Access Compliance Report Public Rights-of-Way (Curb Ramps)

Main Street: WALDEN_ST Cross Street: BANCROFT_ST Location: SW

ADA ID: RPRK211020172724 Ramp Type: Type 4 - Parallel Initial Pass/Fail: Fail Overall Compliance: No Severity Score: 15

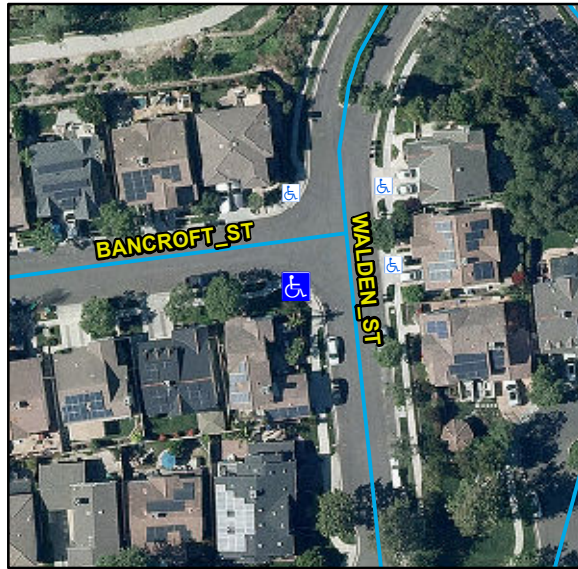
Compliance	Description	Data	Compliance	Description	Data
N/A	Ramp Length LT (in)	114	N/A	Ramp Length RT (in)	112
Yes	Ramp Width LT (in)	53	Yes	Ramp Width RT (in)	53
No	Ramp Run Slope LT (%)	10.7	Yes	Ramp Run Slope RT (%)	2.2
Yes	Ramp Cross Slope LT (%)	0.5	Yes	Ramp Cross Slope RT (%)	0.2
N/A	Landing Present	N/A	N/A	DWS Provided	N/A
N/A	Landing Length (in)	N/A	N/A	DWS Contrast	N/A
N/A	Landing Width (in)	N/A	N/A	DWS Length (in)	N/A
N/A	Landing Run Slope (%)	N/A	N/A	DWS Full Width	N/A
N/A	Landing Cross Slope (%)	N/A		DWS Offset Type	N/A
N/A	Landing Movement Obstructed?	N/A	N/A	DWS Offset Left (in)	N/A
	Landing Movement Type	N/A	N/A	DWS Offset Right (in)	N/A
N/A	Landing Shared	N/A			
N/A	Clear Space	Yes			
N/A	Clear Space To Crosswalk (in)	N/A			
N/A	Marked Crosswalk 1	No	N/A	Marked Crosswalk 2	No
	Crossing 1 Direction	E		Crossing 2 Direction	N
	Marked Crosswalk 1 Width (in)	N/A		Marked Crosswalk 2 Width (in)	N/A

Remove & Replace Curb Ramp With Two New Directional Ramps or Equivalent.
